TE1880-TE-00-XX-CO-GE-003-V01

13 November 2025

**ENVIRONMENTAL HEALTH SENIOR OFFICER COMMENTS PERTAINING TO THE
FOUNDATION WORKS RISK ASSESSMENT RESPONSE LETTER – HOPWOOD HALL COLLEGE,
ROCHDALE PREAPP-00012-25**

CLIENT:	WILLMOTT DIXON
ARCHITECT:	SHEPPARD ROBSON
PROJECT:	HOPWOOD HALL COLLEGE ROCHDALE
TITLE:	BELOW GROUND DRAINAGE GENERAL LAYOUT
SCALE @ A3:	1:200
PROJECT NUMBER:	24365
DRAWING NO:	F0012-ROS-XX-XX-D-C-0500
CHECKED:	JT
DESIGNED:	AY
DRAWN:	AY
DATE:	MAY 2024
APPROVED:	JC
REV:	C01

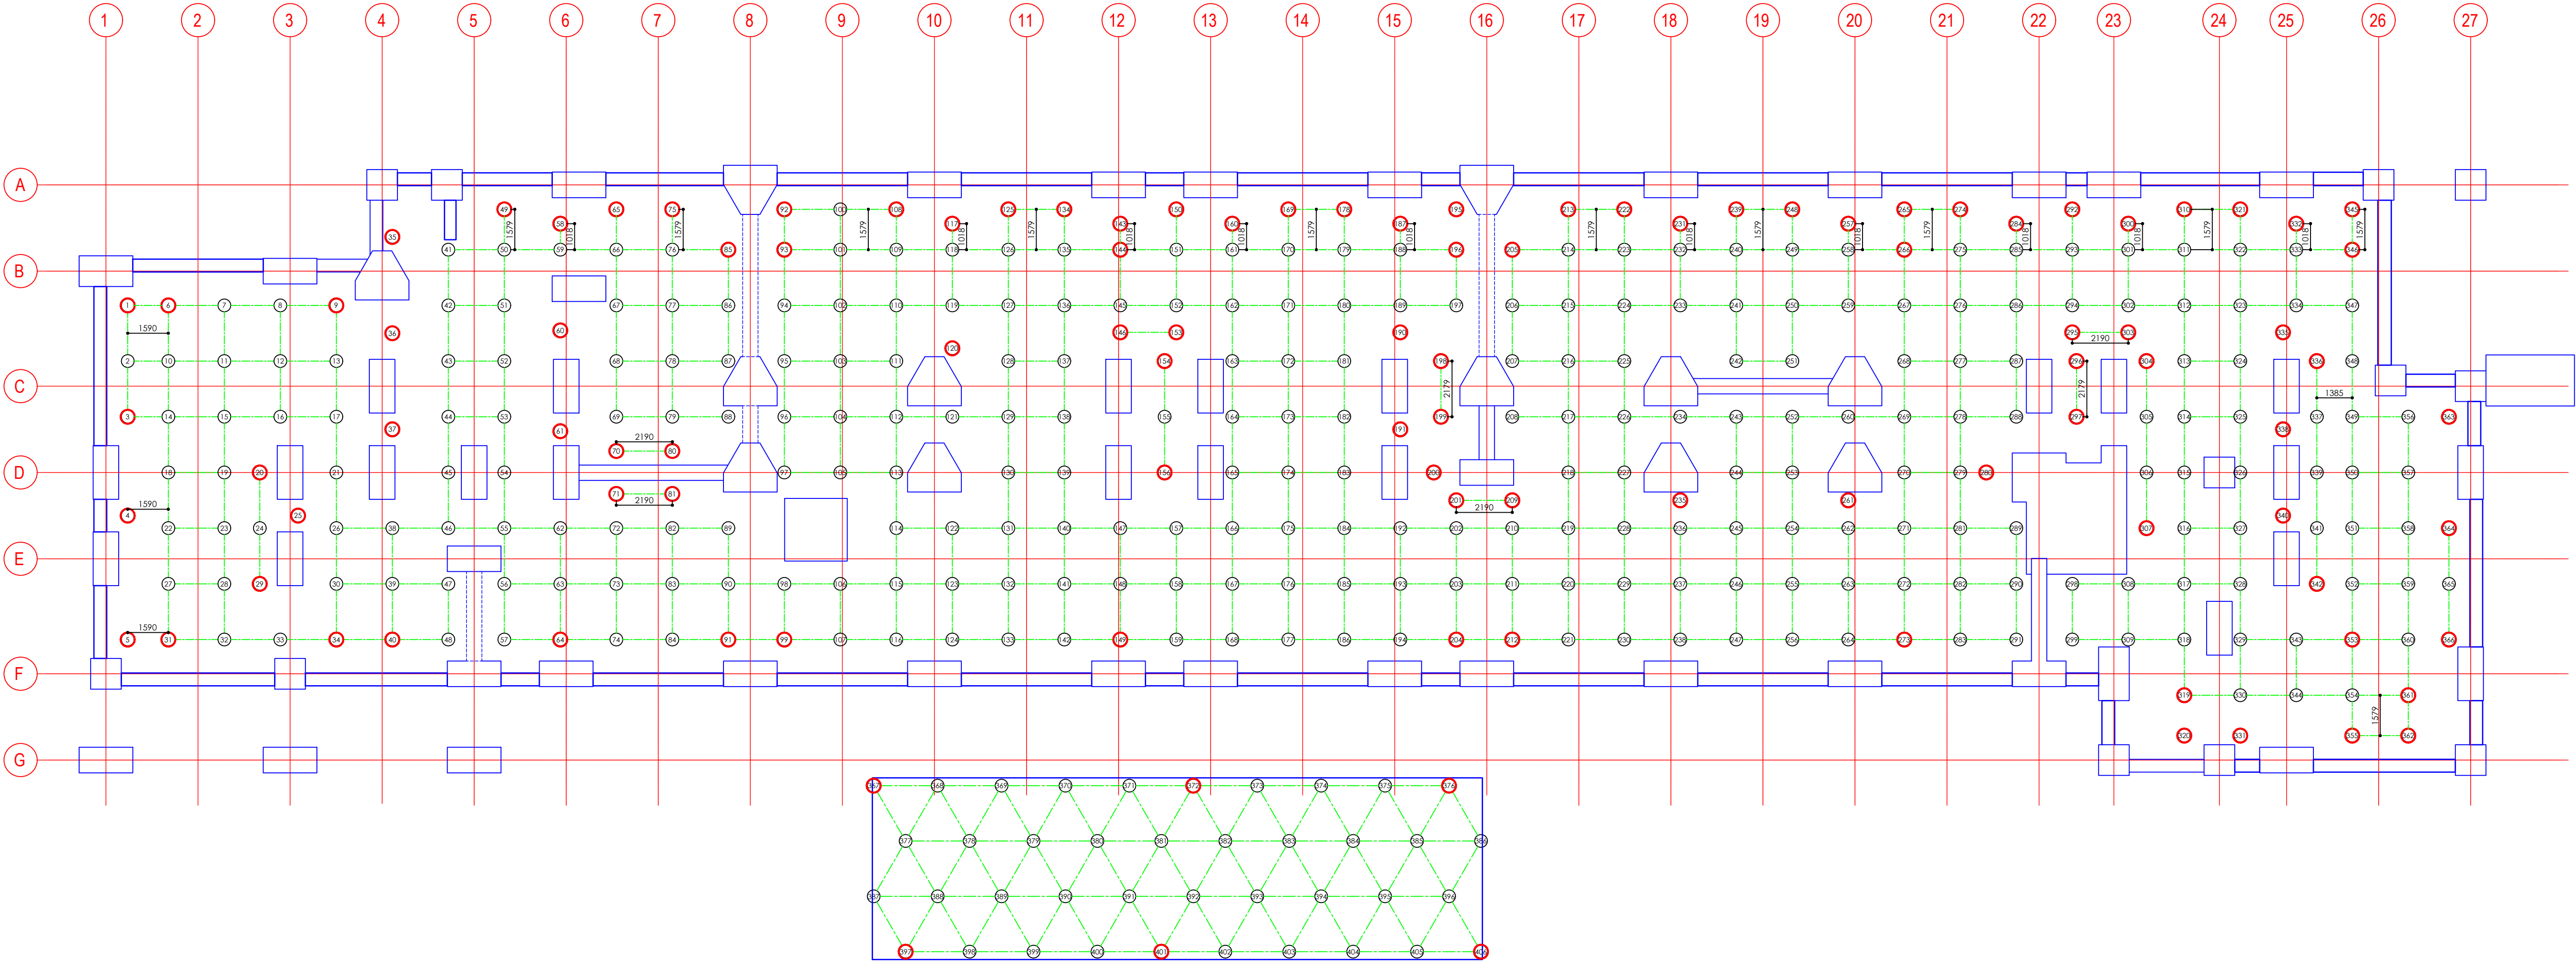
“The proposed pile locations are presented as Drawing No. FE0012-ROS-XX-XX-D-C-0500, Rev C01 produced by Roscoe.”

This drawing does not appear to have been included. Please find attached to this letter. The drawing shows drainage layout but also proposed pile locations.

TITLE:
**STONE COLUMN OVERLAY
UNIT 1**

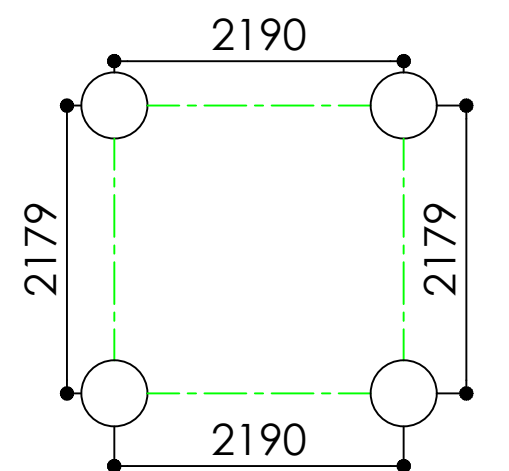
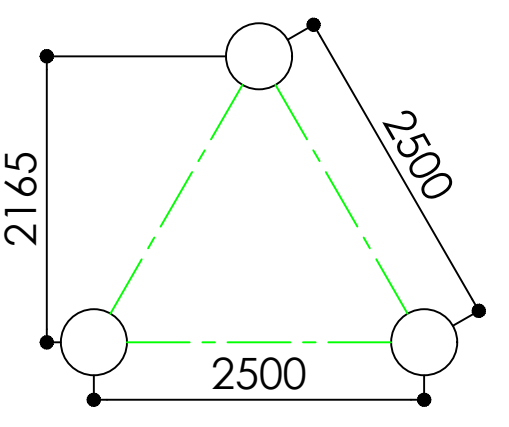
So, are there going to be no VSCs in the area of shallow Made Ground? Are they just to be in areas where the thickness of MG is over 2m? No, VSCs will be positioned as per the attached drawing and do not discriminate based on Made Ground thicknesses.
